SUBJECT: KEWAUNEE NUCLEAR POWER PLANT - ISSUANCE OF AMENDMENT
(TAC NO. MB7225)

The amendment revises the KNPP operating license and TSs to increase the licensed rated power by 1.4 percent from 1650 megawatts thermal to 1673 megawatts thermal using measurement uncertainty recapture.

SAFETY EVALUATION BY THE OFFICE OF NUCLEAR REACTOR REGULATION
RELATING TO AMENDMENT NO. 168 TO FACILITY OPERATING LICENSE NO. DPR-43
NUCLEAR MANAGEMENT COMPANY, LLC
KEWAUNEE NUCLEAR POWER PLANT
DOCKET NO. 50-305

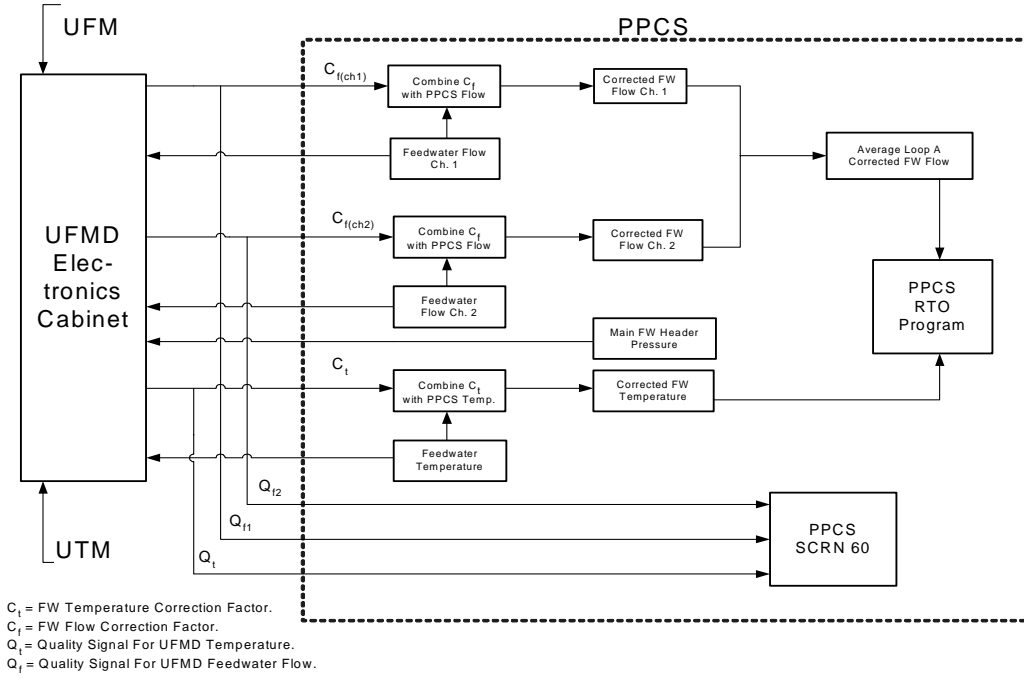
In the licensee's April 30, 2003, letter, NMC provided the figure shown on page 10 for the feedwater alpha or "A" loop data processing and communication links; loop bravo or "B" data processing and communications are identical. This figure was provided as information to facilitate understanding of the system application at KNPP and depicts the integration and operation of the UFMD system and its interface with the plant process computer system (PPCS). The UFMD electronics cabinet takes inputs from the UTM and UFM sensors in each feedwater loop. These sensor signals are processed using the Crossflow software for the UFM's and the CORRTMP software for the UTM's. The UFMD generated values of flow and temperature are compared with existing venturi flowmeters (venturis) and resistance temperature detector (RTD) signals provided from the PPCS to develop instantaneous and average UFMD correction factors, C_f and C_t , respectively for the two feedwater flow instrument channels (UFM flow/PPCS flow) and feedwater temperature channel (UTM temp/PPCS temp) in each loop. Quality factors, Q_f and Q_t , for each correction factor are generated in the UFMD electronics cabinet by Crossflow and CORRTMP software and sent to the PPCS screen (PPCS SCRIN). The quality factor data is determined and saved with the corresponding correction factor. The UFMD software running in the UFMD electronics cabinet ensures the correction factors are maintained within the required uncertainty. Individual correction factors for feedwater flow and temperature are provided from the UFMD to the PPCS and are used to calculate the corrected feedwater flow and temperature to be used by the PPCS RTO program. The RTO is used for monitoring reactor power such that the operator can control reactor power to less than the licensed limit.

The KNPP Crossflow UFM was calibrated according to the topical report CENPD-397-P-A, Revision 1 dated May 2000. A UFM in feedwater loop "A" is installed where the flow is fully developed. As such, this UFM does not need calibration. The UFM in feedwater loop "B" is installed where the flow is not fully developed and thus needed a one-time in-situ calibration. For this calibration, a temporary stand-alone UFMD was installed on the full flow feedwater bypass line. The temporary UFM was installed at a location in the bypass line meeting the conditions for fully developed flow and was used for the UFM "B" calibration.

The NRC staff finds that the licensee's response to the plant-specific requirements stated in the NRC's safety evaluation for topical report CENPD-397 were appropriately addressed and are acceptable.
